REMARKS

This amendment is in response to the Office Action of April 6, 2006.

Serial No. 10/791,191

Fig. 5A

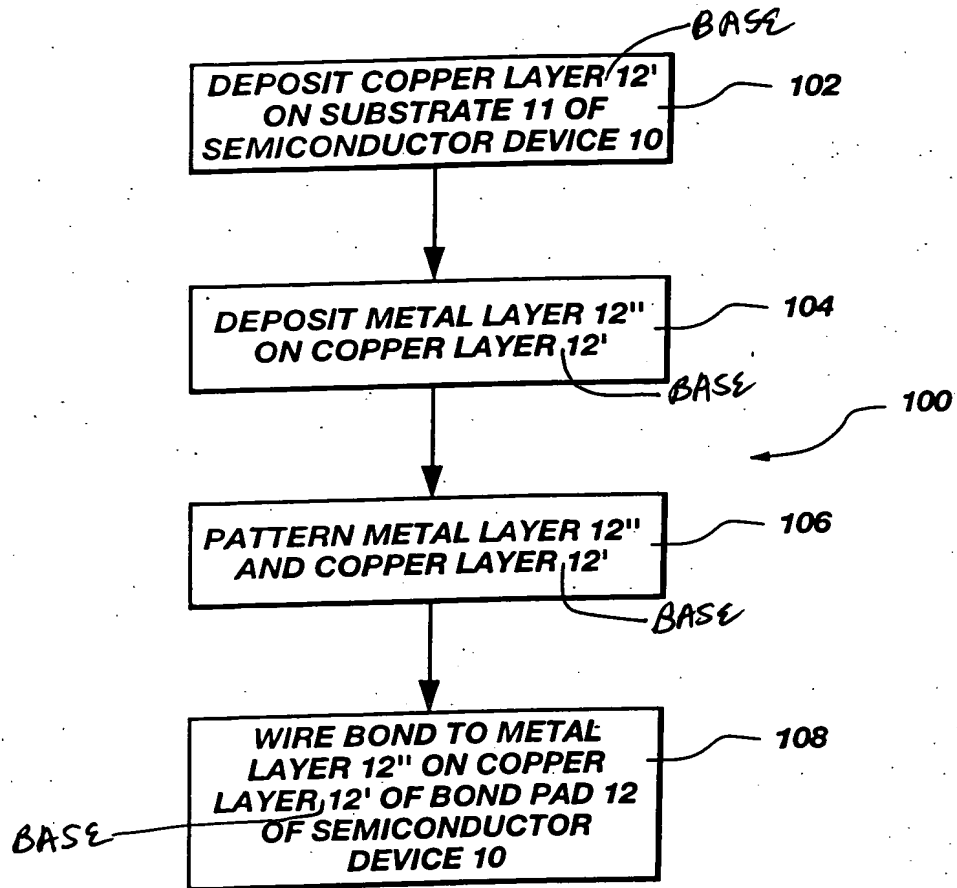
Specifically, FIG. 5A has been revised to insert the word **--BASE--** after the word **--LAYER--** and before the reference numeral **--12'--** on the first line of box 102, second line of box 104, second line of box 106 and third line of box 108; FIG. 5B has been revised to insert the word **--BASE--** after the word **--LAYER--** and before the reference numeral **--12'--** on the second line of box 204, second line of box 206, and third line of box 208; FIG. 5C has been revised to insert the word **--BASE--** after the word **--LAYER--** and before the reference numeral **--12'--** on the first line of box 302, second line of box 304, second line of box 306, second line of box 308 and third line of box 312; FIG. 5D has been revised to insert the word **--BASE--** after the word **--LAYER--** and before the reference numeral **--12'--** on the first line of box 402, second line of box 404, first line of box 408, and third line of box 410; FIG. 5E has been revised to insert the word **--BASE--** after the word **--LAYER--** and before the reference numeral **--12'--** on the first line of box 502, second line of box 504, first and fifth lines of box 508, and third line of box 510; FIG. 5F has been revised to insert the word **--BASE--** after the word **--LAYER--** and before the reference numeral **--12'--** on the first line of box 602, second line of box 604, second line of box 606, and fourth line of box 608; FIG. 5G has been revised to insert the word **--BASE--** after the word **--LAYER--** and before the reference numeral **--12'--** on the first line of box 702, first and second lines of box 704, second line of box 706, and fourth line of box 708; FIG. 5H has been revised to insert the word **--BASE--** after the word **--LAYER--** and before the reference numeral **--12'--** on the first line of box 802, second line of box 804, third line of box 806, second line of box 808, and fourth line of box 812; FIG. 5I has been revised to insert the word **--BASE--** after the word **--LAYER--** and before the reference numeral **--12'--** on the first line of box 902, second line of box 904, first line of box 908, and fourth line of box 910; and FIG. 5J has been revised to insert the word **--BASE--** after the word **--LAYER--** and before the reference numeral **--12'--** on the first line of box 1002, second line of box 1004, first and fifth lines of box 1008, and fourth line of box 1010.
